Addendum No. 001 (CORRECTED)

Subject: Boiler Plant Replacement Bid Package
General, Mechanical, & Electrical
SDP Contract No. B-108c/109c/110c of 2017/18

Location: Mastbaum High School
3116 Frankford Avenue
Philadelphia, Pennsylvania 19134

This Addendum, dated May 09, 2019, shall modify and become part of the Contract Documents for the work of this project. Any items not mentioned herein, or affected by, shall be performed strictly in accordance with the original documents.

DRAWING NO.
P-101
SHEET 19 OF 26

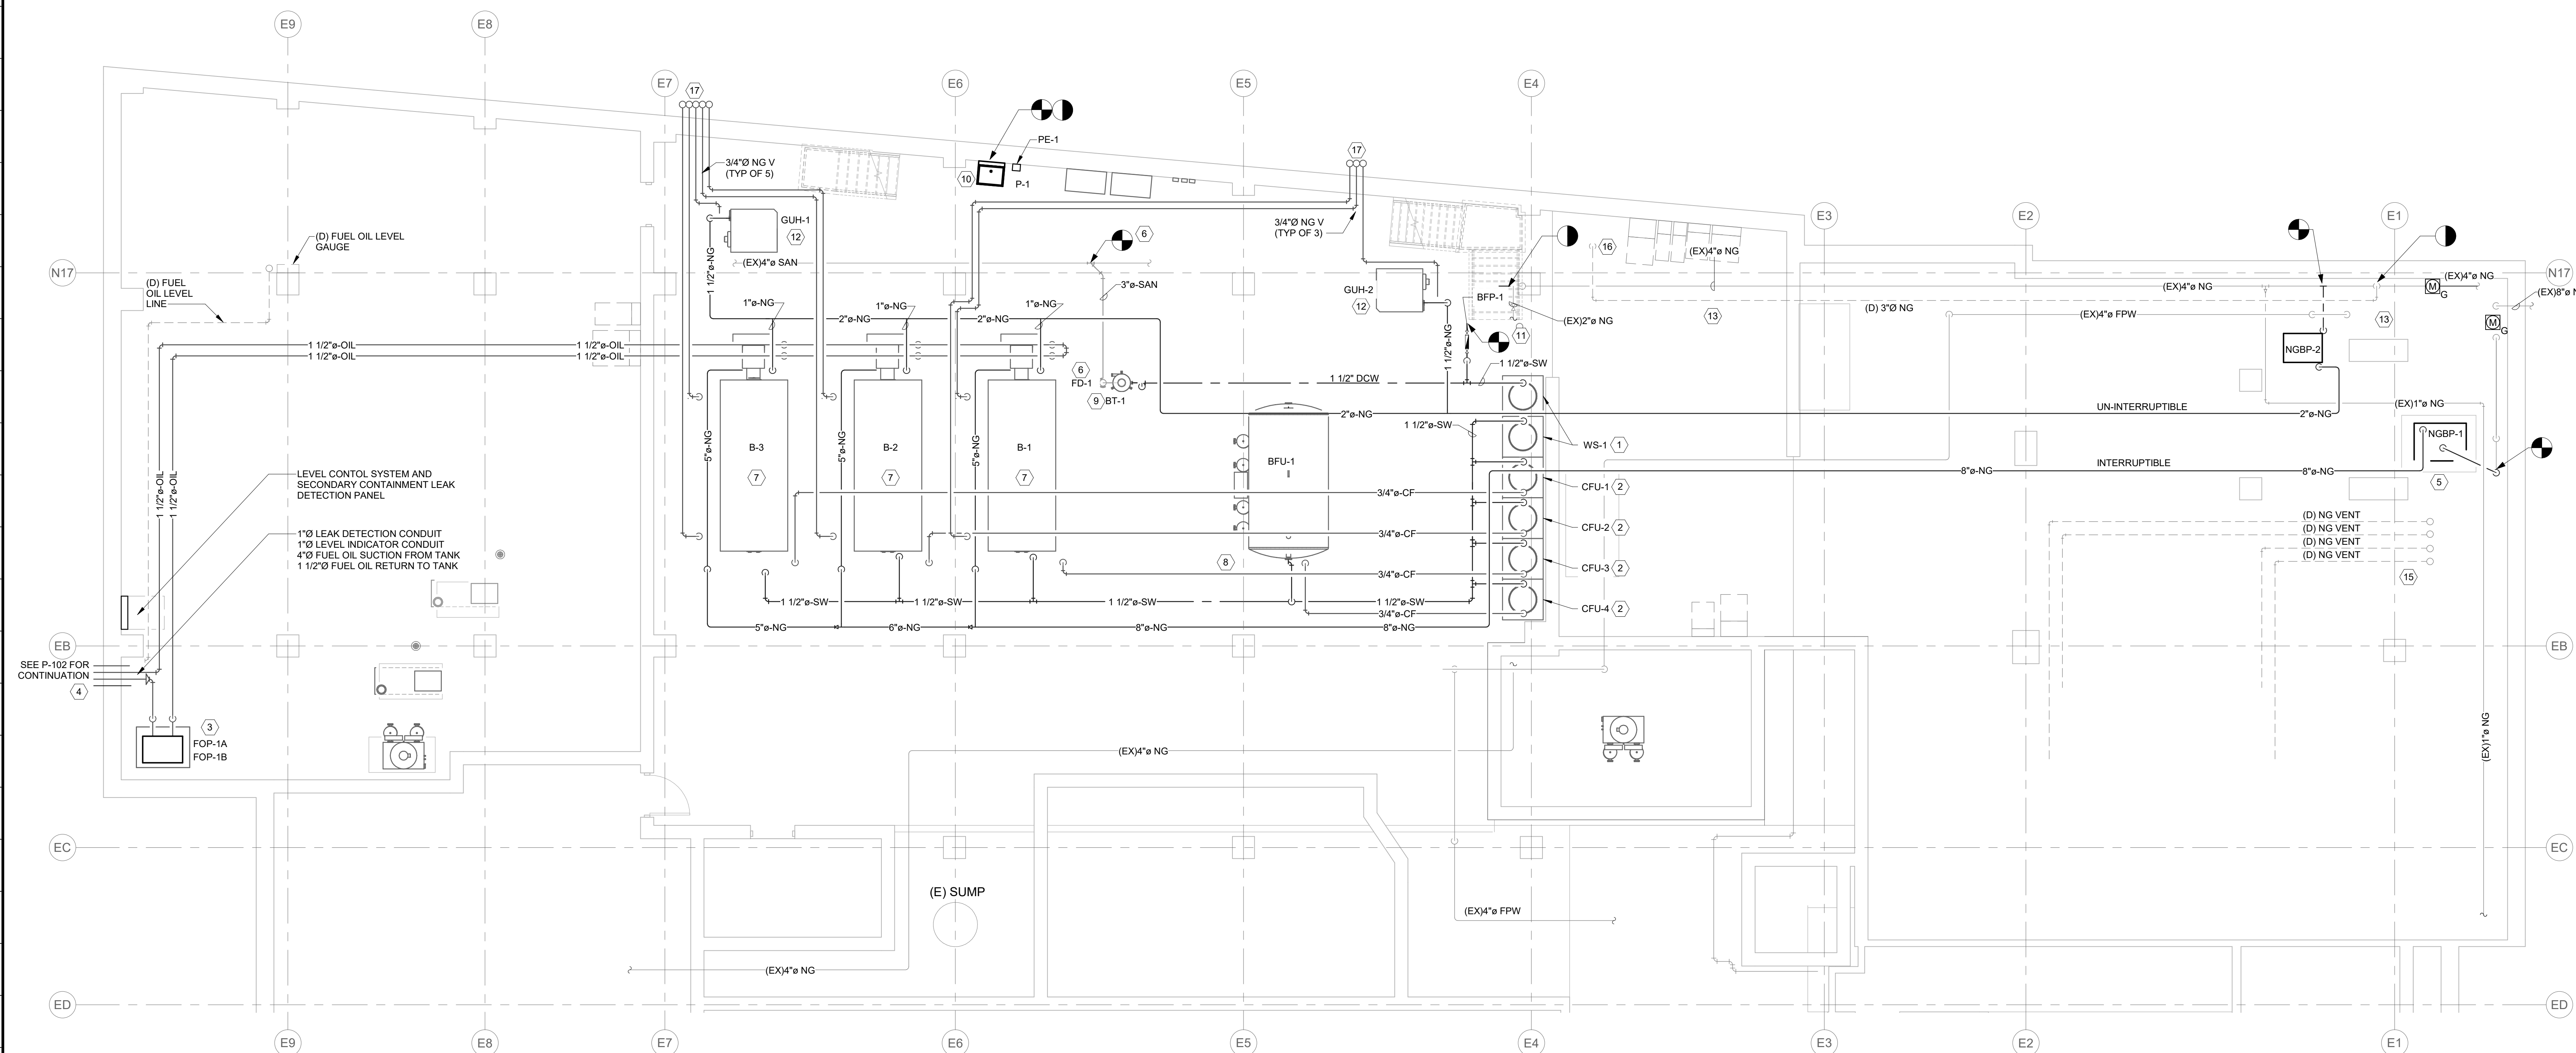
- 2.1.10** REPLACE P-101 with Addendum 001 Version. [See attached]
- 2.1.11** ADD Drawing P-102, Plumbing Fuel Oil Tank demolition and New Work [See attached]

- 2.1.12** Drawing E-401: ADD 120V wiring and conduit circuit from the remote overflow alarm panel to Panel PPBA. Refer to P-102.
- 2.1.13** Drawing E-401: ADD 120V wiring and conduit circuit from the level control system and secondary containment leak detection panel to PPBA. Refer to P-101.
